Device Errata

Skywire[®] Raspberry Pi Adapter

NimbeLink Corp

Updated: July 2017

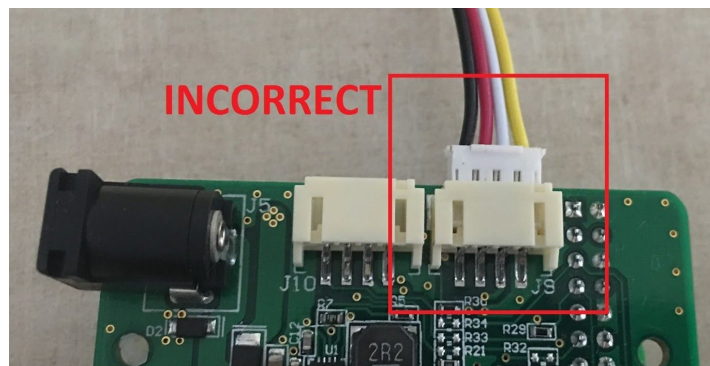
Applications using the Grove connectors on NL-AB-RPI adapter board with PCB revision 1001430 REV A are affected. The grove connector pins are reversed, as shown in the image below. Users who wish to use Grove sensors on affected PCBs must follow the steps outlined in section four of this errata.

Grove sensors using unmodified cables should not be directly attached to the Grove connectors on affected boards as this may cause shorts and/or damage to the sensor or Raspberry Pi.

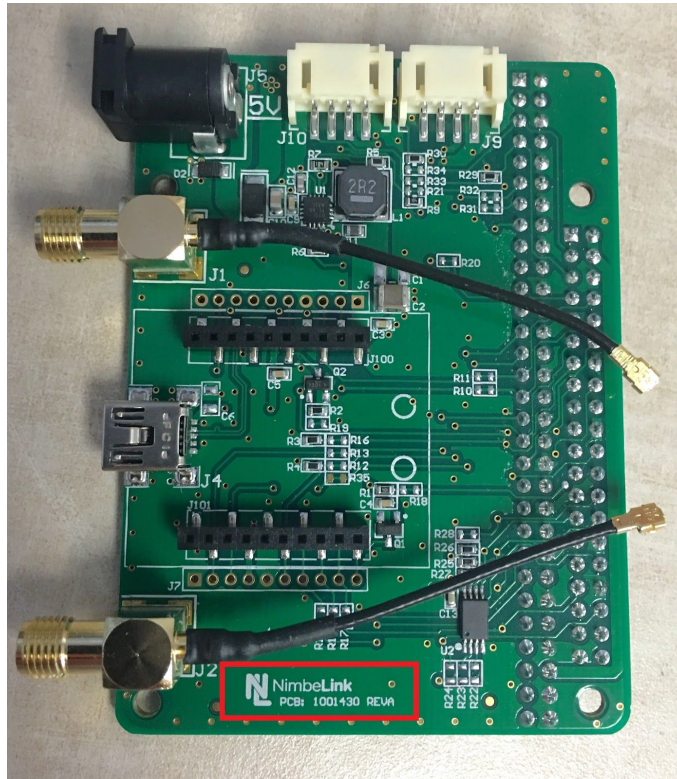
The PCB revision number is located on the bottom of the top side of the PCB. This Errata affects all NL-AB-RPI boards with a PCB revision number of 1001430 Rev A.

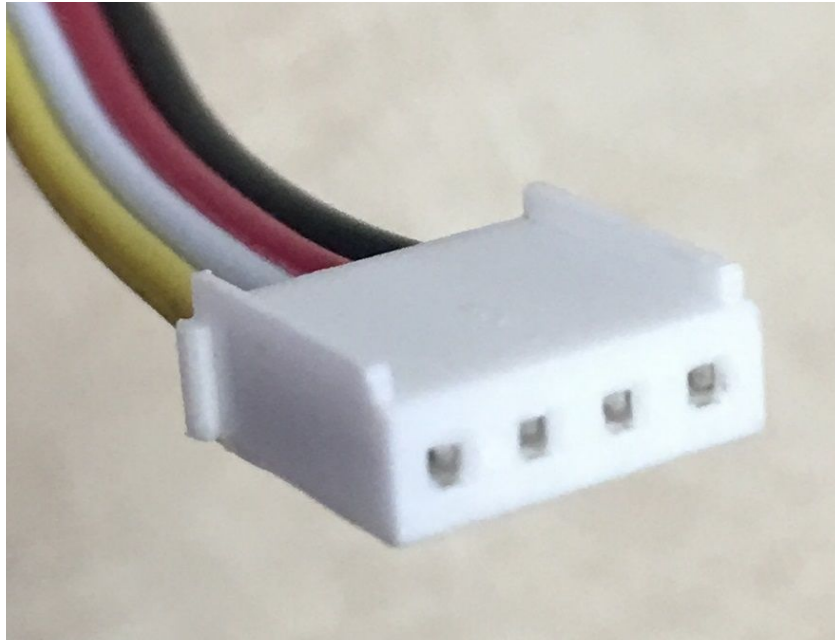
The suggested workaround is to modify the Grove sensor cable connector to allow it to be plugged into the adapter upside down. Users will need to remove the polarity tabs from the Grove connector on the cable. To remove the tabs follow these steps:

1. Identify the side of the cable that will be modified.

2. Use a razor blade to remove the two tabs.
